BCN 2.0: Issues and Questions

Bruce Kwan (Broadcom Corp)

IEEE 802.1 Interim Meeting
Beijing, China
May 16, 2006

Queue Depth Units

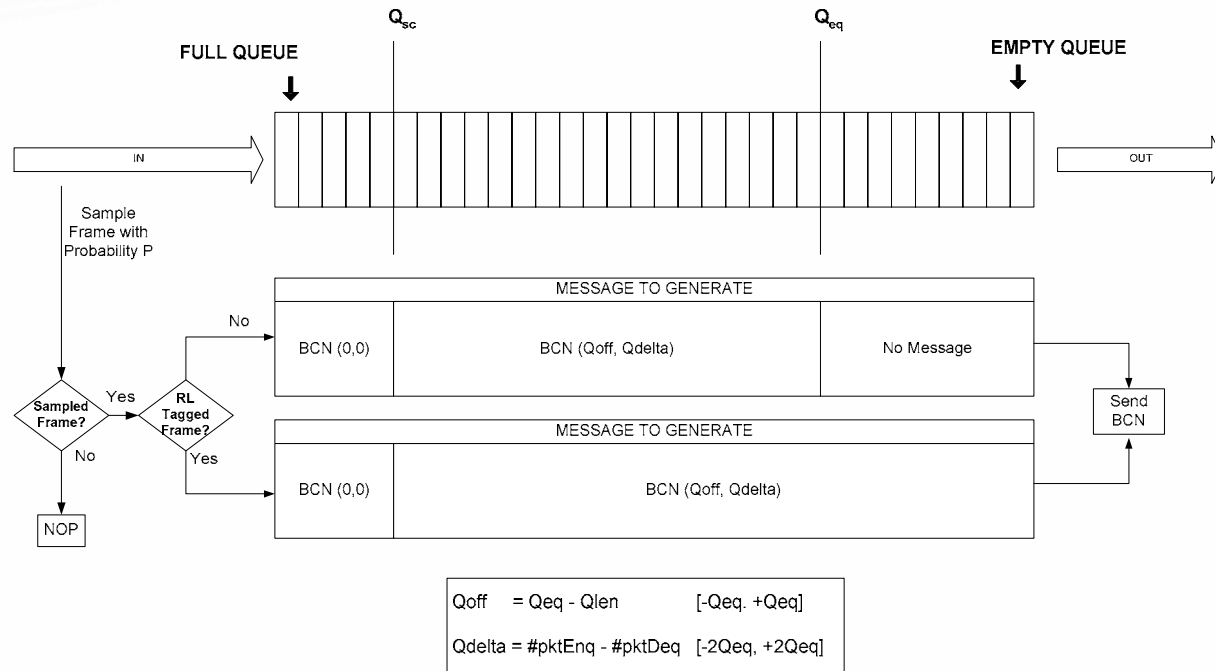
- Ethernet switch implementations use varying architectures for buffer allocation.
- Protocol should support accurate report of queue utilization across a variety of implementations.

Queue depth in packets is not a good measure of of buffer utilization.

RL Queue Management

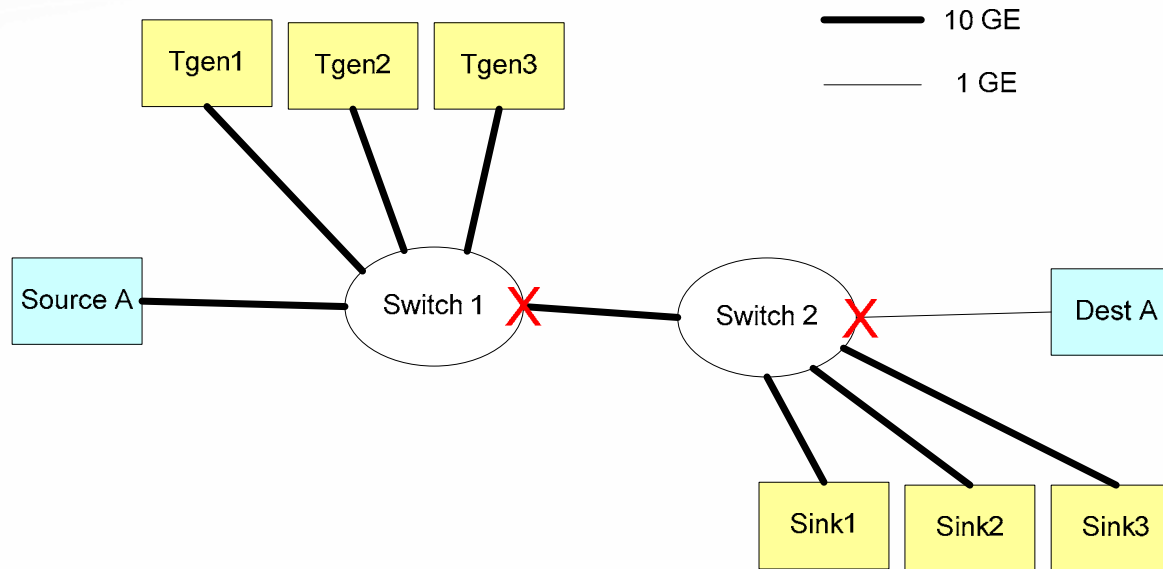
- When is the RL queue at the reaction point no longer used to rate limit the traffic that contributed to congestion?
 - Rate at the RL Queue == link speed &&
 - RL Queue is empty
- How is multicast handled?
- When there are not sufficient RL Queues at the Reaction Point to handle all of the current congestion points, what are the rules for managing these resources?

Handling Multiple Congestion Points

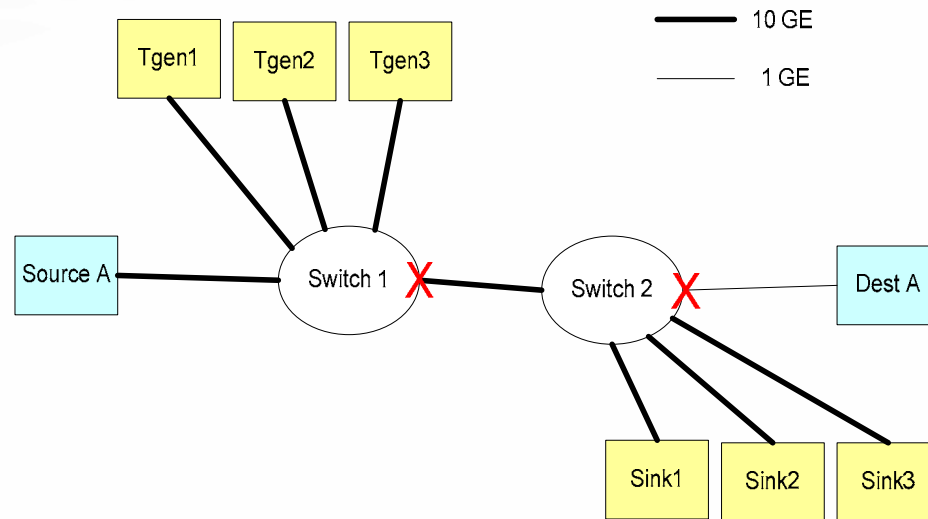
- TgenN sends to SinkN (N=1,2,3) in a bursty on-off pattern
- SourceA sends to Dest A
- SourceA is contributing to both congestion points using a single flow
- Ideally, SourceA would be able to detect the worst case congestion across the multiple congestion points and respond accordingly.

- How should the Reaction Point in SourceA handle the case where it is receiving multiple BCN messages from different CP's for the same flow?
 - Which CPID goes in the RLTag?
 - Congested CP handling for a packet with a foreign CPID in RLTag?
 - Reaction point may receive conflicting BCN messages from the two different CPID's

Slow Recovery from Congestion

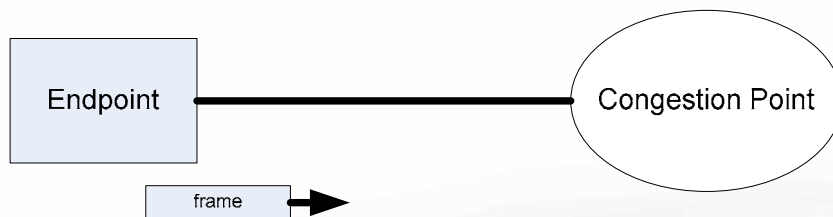
- **Example:**
 - Suppose the rate at an RL queue is 8Mbps
 - For 1500 byte frames, sending 100 frames requires ~150ms
 - This implies that after congestion subsides, it would take at least 150ms (on avg) to receive an initial BCN message directing the RL queue to additively increase its rate.
 - This seems like a long time
- Is there support in the protocol to mitigate these effects?

RL Tag Format (Alignment Issue)

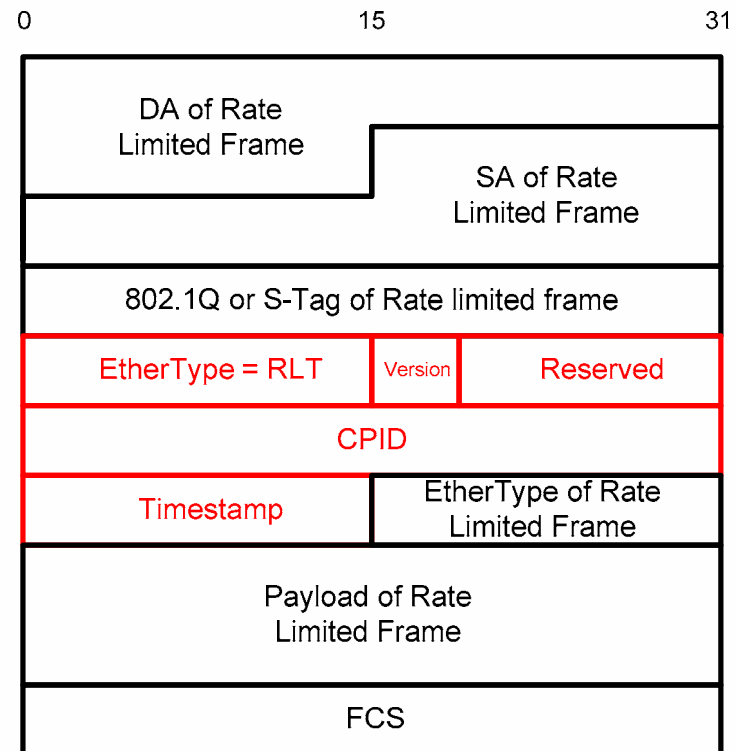
- Viewing a frame as an array of 4-byte words, usually Ethertype is the first two bytes of a word.
- RLT Tag format puts the Ethertype of the rate limited frame in the last two bytes of the word which implies a two-shift of word alignment for the whole frame.
- This is awkward for some implementations inserting and deleting tags. The format should maintain 4-byte alignment of encapsulated frame.

Simulation Setup Clarification

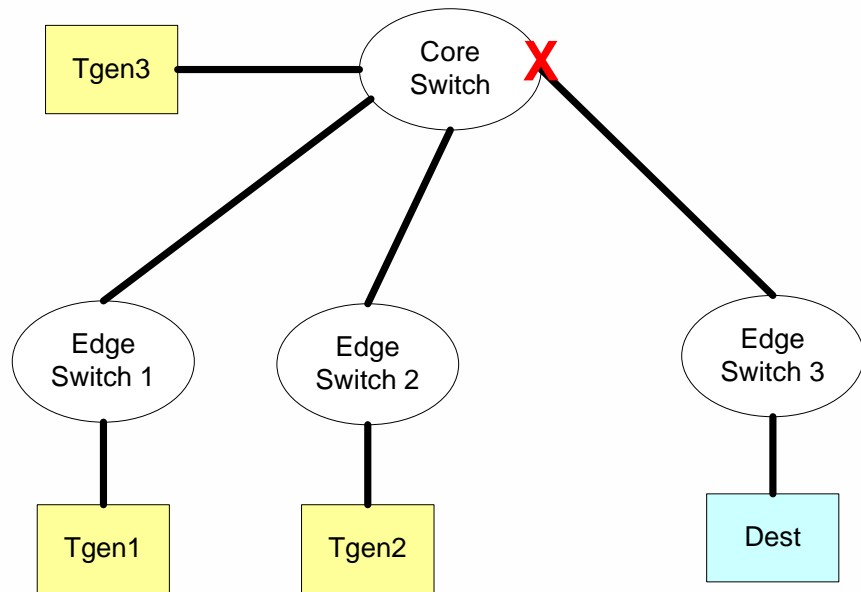
- What flavor of TCP is used?
 - Tahoe, Reno, New Reno, SACK
- What TCP parameters are assumed?
 - Window size
 - Slow Start
 - Quick Start
 - Nagel
